**From:** Anthony Witherdin <[REDACTED]>  
**Sent:** Thursday, 13 May 2021 10:33 AM  
**To:** Kate Moore <[REDACTED]>  
**Cc:** Amy Watson <[REDACTED]>; Anthea Sargeant  
<[REDACTED]>; David Glasgow <[REDACTED]>  
**Subject:** Harbourside Shopping Centre Redevelopment (SSD 7874)

## HARBOURSIDE REDEVELOPMENT (SSD 7874)

## **RE: Harbourside Shopping Centre Redevelopment, SSD 7874 - Response to IPC**

**Figure 4 Building Envelope Comparison (left: recommended for approval and right: IPC option)**

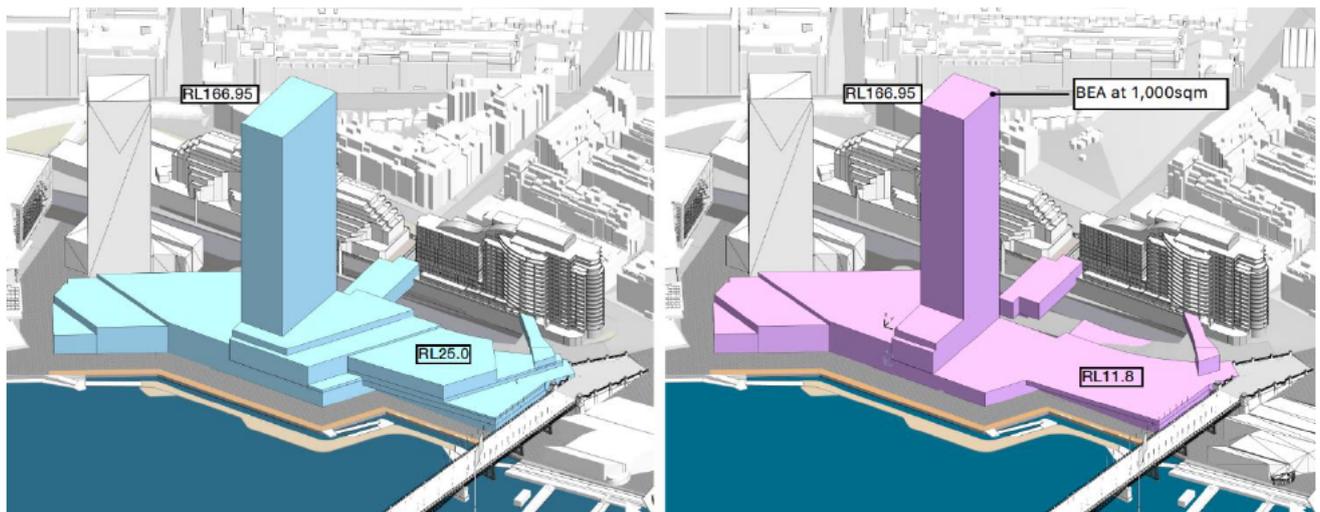
In its correspondence the IPC requested analysis of an alternative building envelope option that involves significant reductions to the northern podium height and tower envelope.

Figure 4 below illustrates the building envelope as recommended by the Department for approval together with the building envelope option requested by the IPC to be analysed.

**Figure 6** Existing Harbourside Shopping Centre

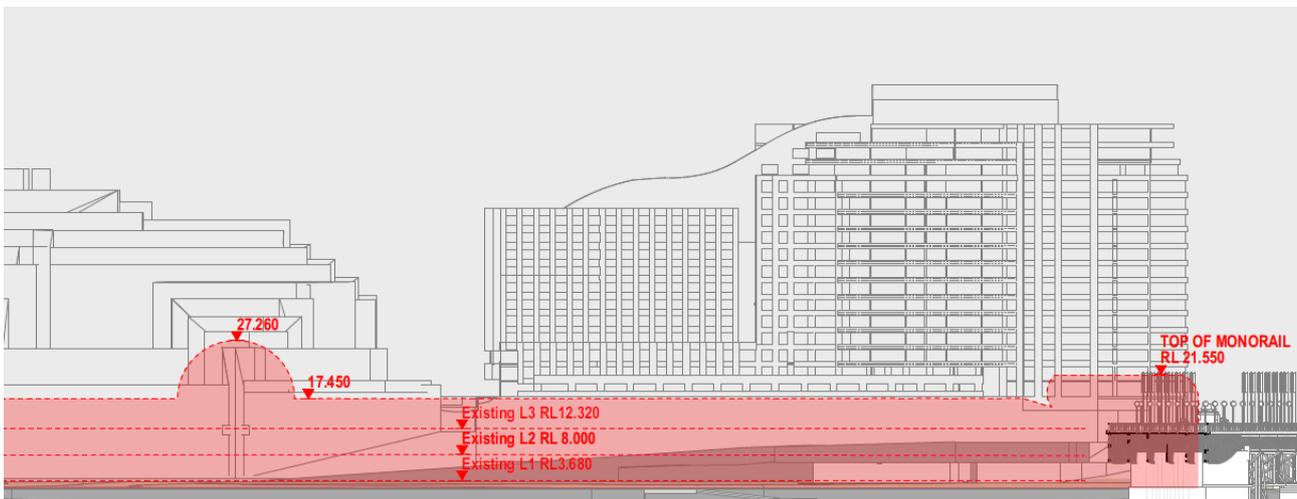
In reviewing this option it is important to appreciate that the existing Harbourside Shopping Centre has a predominant maximum height of RL17.45 (refer to **Figure 6**). So an option to reduce the proposed northern podium envelope to a height of RL11.8 would be significantly lower than the existing development on the site (over 5m lower). As a principle an option that involves reinstating a building that is significantly lower than the existing development is therefore considered unreasonable.

Figure 7 Podium Height Study (current envelope illustrated in blue)

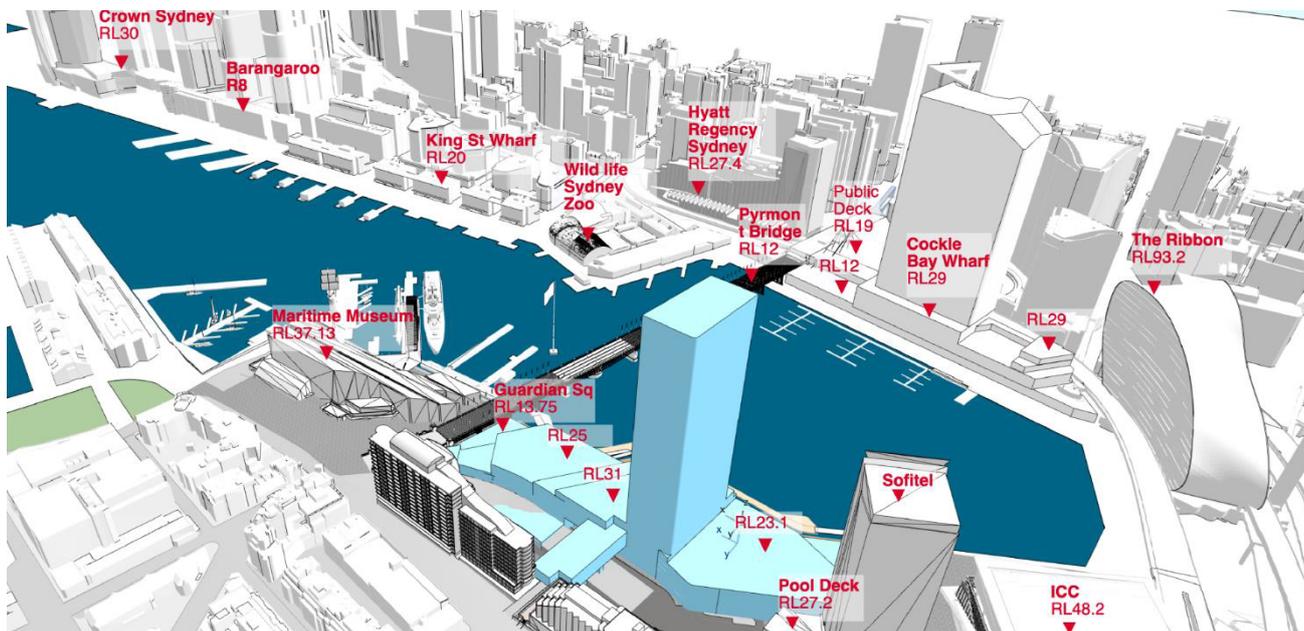
A further factor that should be considered when reviewing this option is the broader context of buildings that adjoin and front Cockle Bay. As illustrated in **Figure 7** below, there is a predominant podium height that ranges from RL17 (existing Harbourside Shopping Centre) to RL30. More locally, it is noted that the Maritime Museum to the north of the site has a height of RL37.13 and the ICC to the south has a height of RL48.2.

Figure 8 Overlay of design impact to northern podium

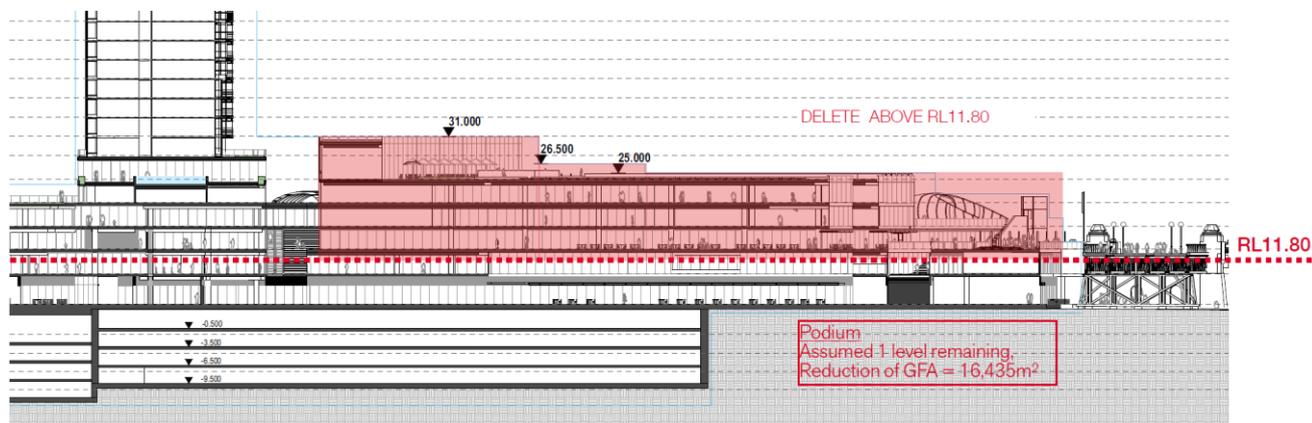
Fjmt have undertaken a study as to the implications of the design in order to accommodate a maximum northern podium of RL11.8 (refer to Figures 8 and 9). This study reveals that the reduced envelope would have the effect of only supporting a single level of retail at ground level, as there would not be enough height below RL11.8 to accommodate the necessary floor to floor heights for a second level of retail/commercial (provision for only 2.05m where 4m is required).

**Figure 10 Tower Floor Plate Analysis (current envelope in yellow and IPC option in blue)**

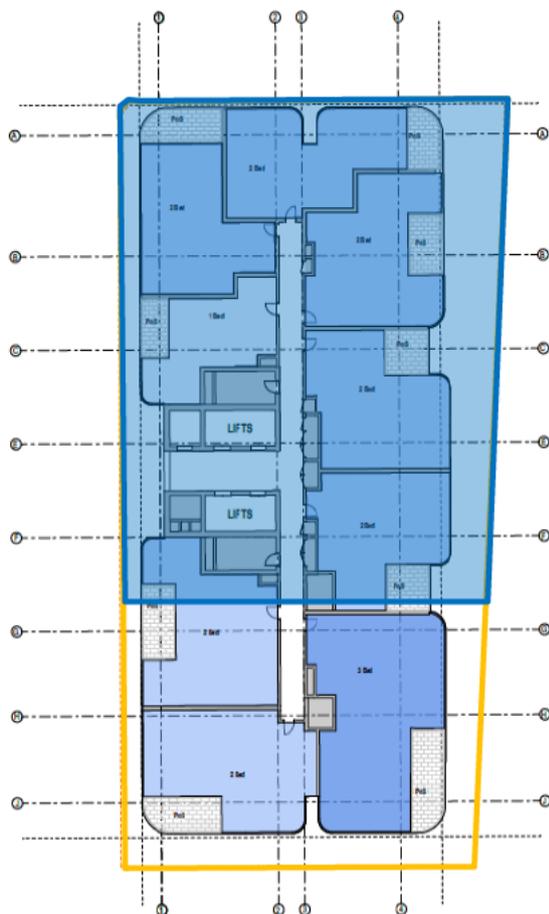
The IPC seeks to test an option that involves reducing the tower envelope from its current size of 1,507sqm down to 1,000sqm. Table 3 and Figure 10 illustrate the impact such a reduction would have in terms of the size and floor area able to be accommodated within a typical tower level.

**Figure 14 Mirvac Alternative Built Form Envelope Option**

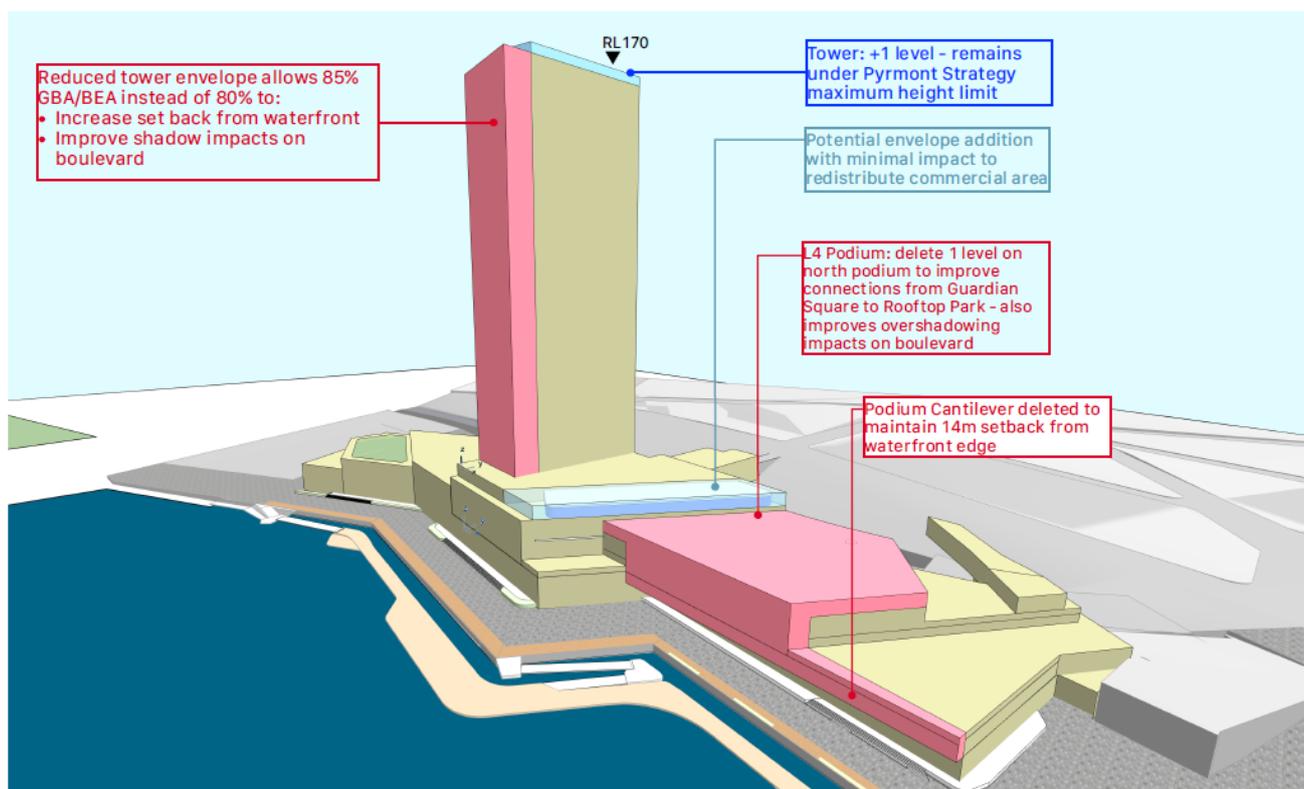
Mirvac have accordingly developed an alternative option that importantly addresses the underlying concerns of the IPC in terms of further increasing solar access to the public domain, improving access to public open space, and further reducing private view impacts while balancing Mirvac’s vision and the project’s viability (summarised in **Figure 14**).

**Figure 15 Podium – Alternative Building Envelope Option**

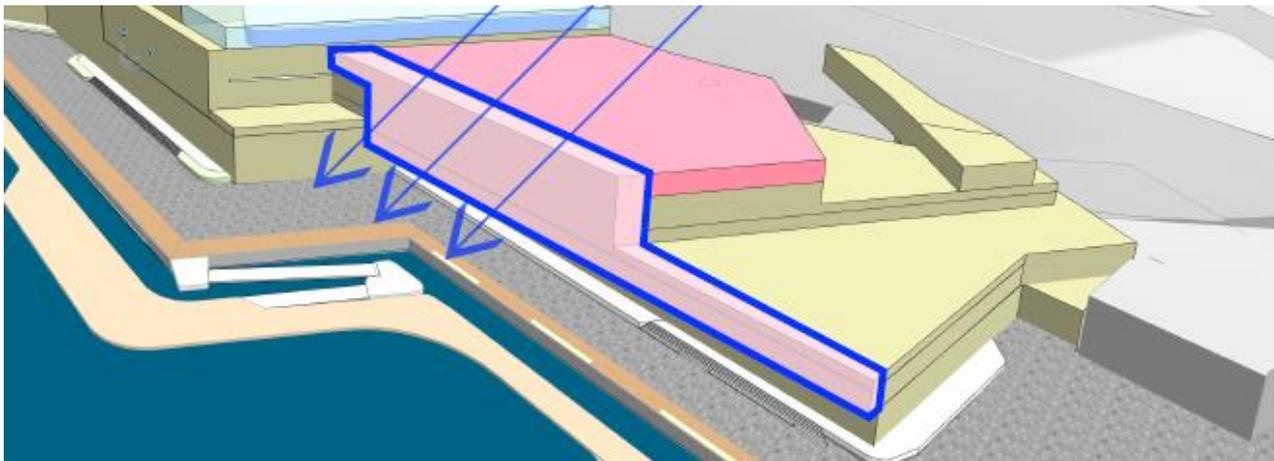
1. Removal of podium overhang to foreshore – achieving a consistent 14m setback to the foreshore (refer area in pink in **Figure 15**).
2. Removal of an entire level of the podium (from RL25 to RL21.35) – refer to area in red in **Figure 15**.

**Figure 17** Shadow Diagram – 21 June, 1pm (area highlighted in red represents reduced overshadowing)

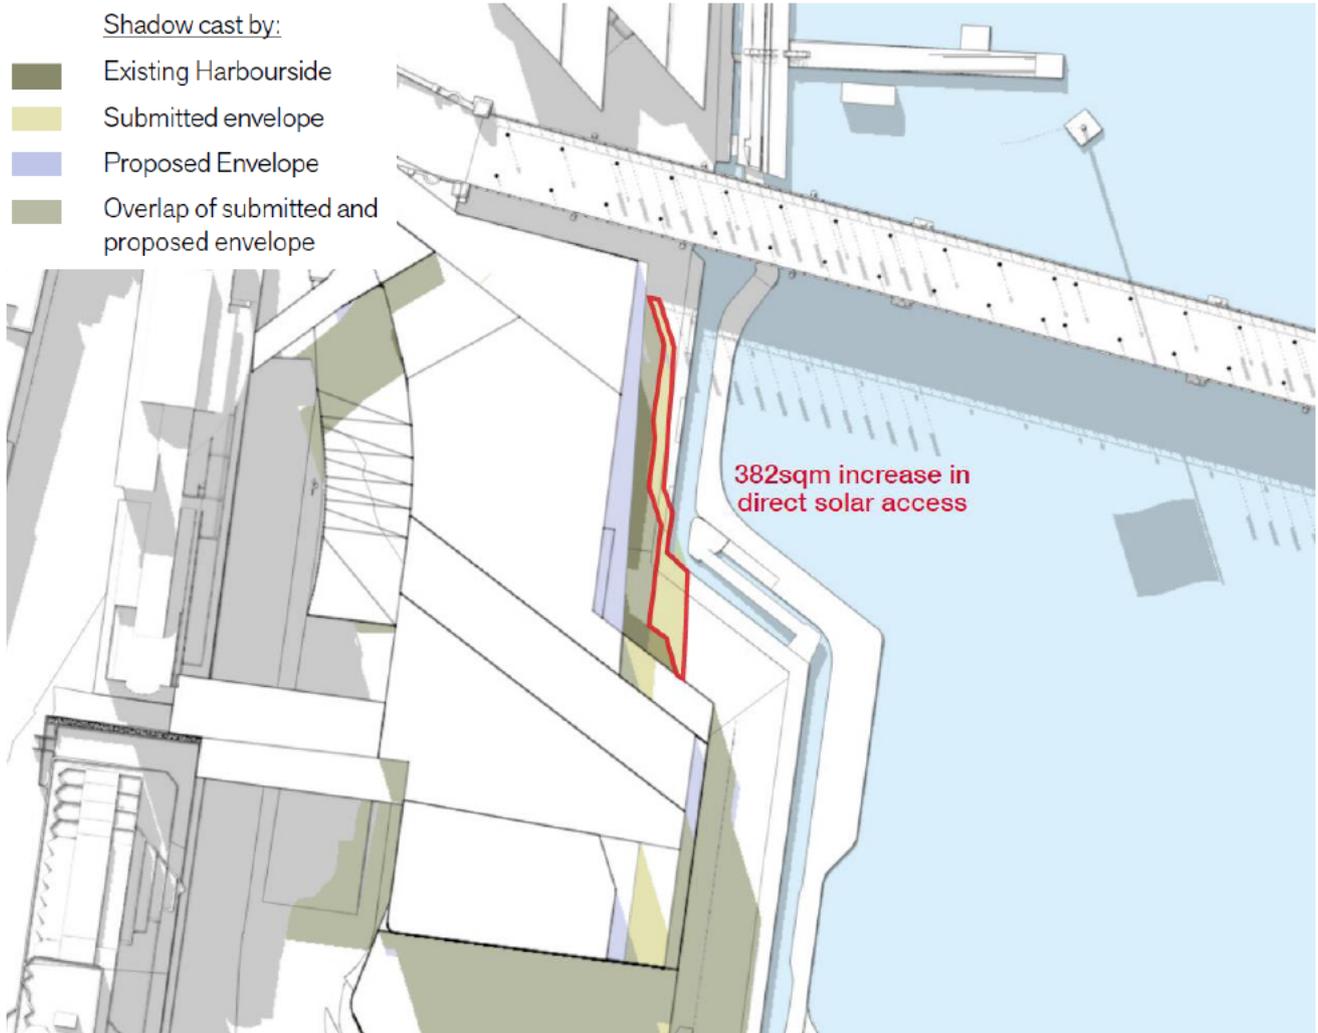
Detailed shadow diagrams are included within **Attachment A**, with an extract from June 21 at 1pm provided in **Figure 17** below. The area highlighted in red illustrates the additional solar access able to be provided to the foreshore promenade as a result of adopting the alternative building envelope option. In other words, this area in red is overshadowed under the current submitted envelope, and when adopting Mirvac's proposed alternative building envelope it would receive direct solar access.

**Figure 20 Tower Floor Plate Comparison (current envelope in yellow, alternative option in red, and IPC option in blue)**

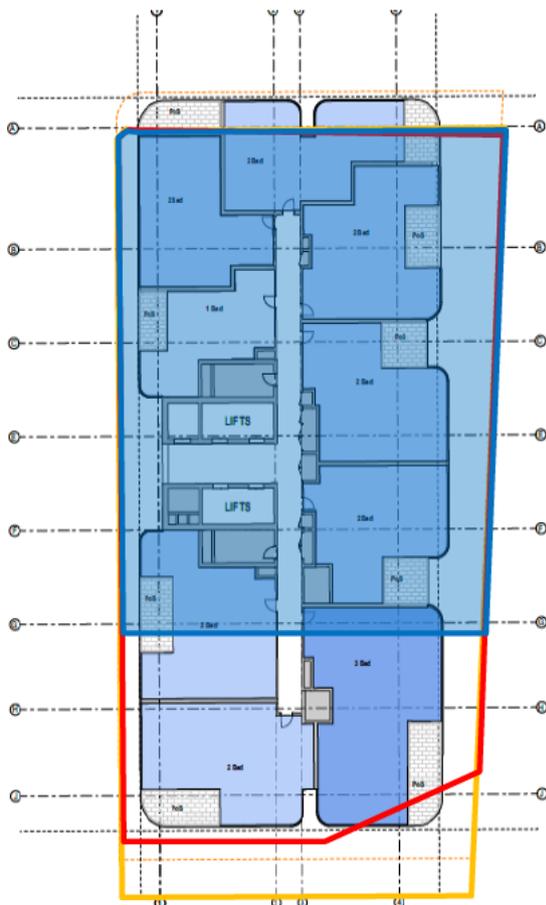
A comparison between the current tower floor plate and Mirvac’s alternative option is provided in **Table 4** and **Figure 20**. Crucially, the building envelope is reduced in size and ensures a future tower is setback further from the promenade and foreshore (increasing from 32m to 36m), while also continuing to achieve a viable floor plate for Mirvac (assuming 85% utilisation is applied) and aligns with the City of Sydney’s controls in terms of floor plate size and envelope utilisation.

**Figure 22 Northern podium current proposal and alternative option**

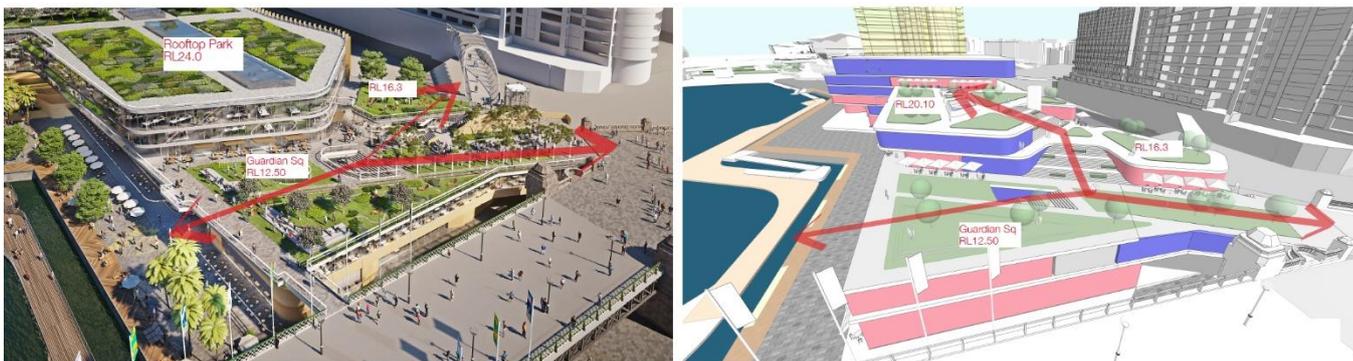
Through reducing the upper-level podium height by a level it enables the committed 2,000sqm of public open space to be lowered in height which has the added significant benefit of improving direct and convenient access to this space from Guardian Square and Pyrmont Bridge (refer to **Figure 22**). Fjmt have developed an indicative design that now illustrates clear and visible connections across the various levels of the 3,500sqm of public open space (refer to **Figures 23 – 24**). It has always been Mirvac’s intent to ensure the 3,500sqm of public open space is accessible and contiguous, with this option now assuring this outcome is more readily and easily achievable.

Figure 26 View from 50 Murray St - Apartment 201 (Current Proposal)

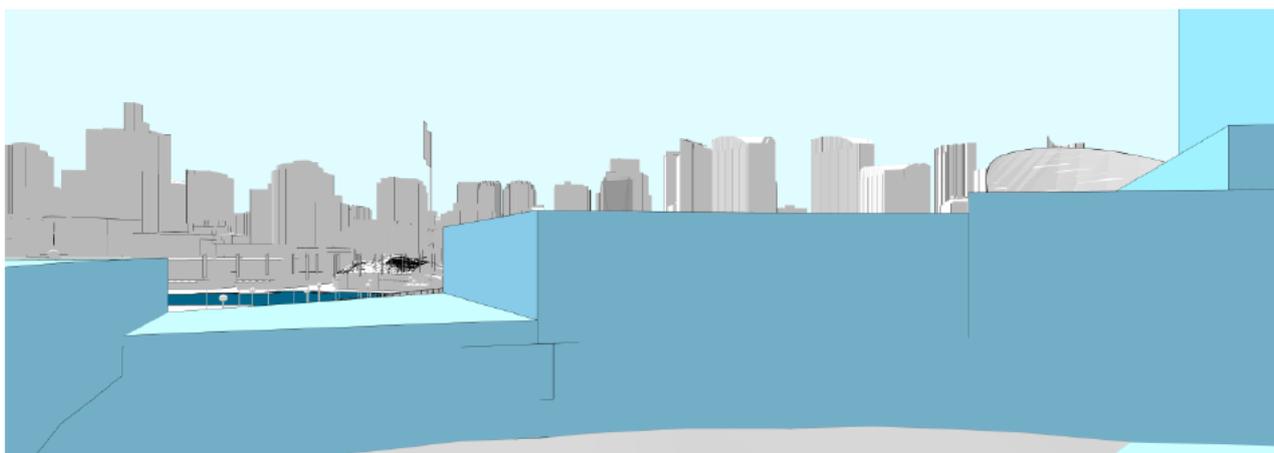
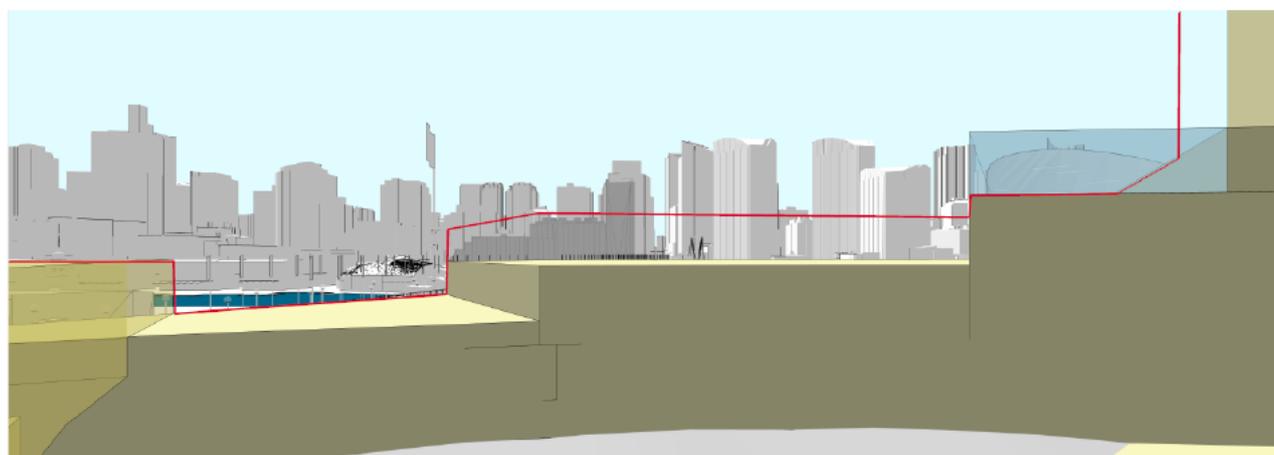
A further key improvement to reducing the height of the podium is the further reduction in private view impacts experienced from apartments within 50 Murray Street. Noting the current proposal has already been deemed acceptable and reasonable in terms of view impacts by both the proponent and its experts along with the Department, this alternative building envelope option would further strengthen the justification for supporting the proposal (refer to **Figures 26 and 27** below and **Table 5**). Fjmt have prepared images from a select number of apartments within the low-rise of the building (being that portion most affected), including Apartment 201 (refer to **Figures 25 and 26** below and **Table 6**) and 501 (refer to **Figures 28 and 29** below and **Table 5**) which were both visited during the IPC Site Inspection.
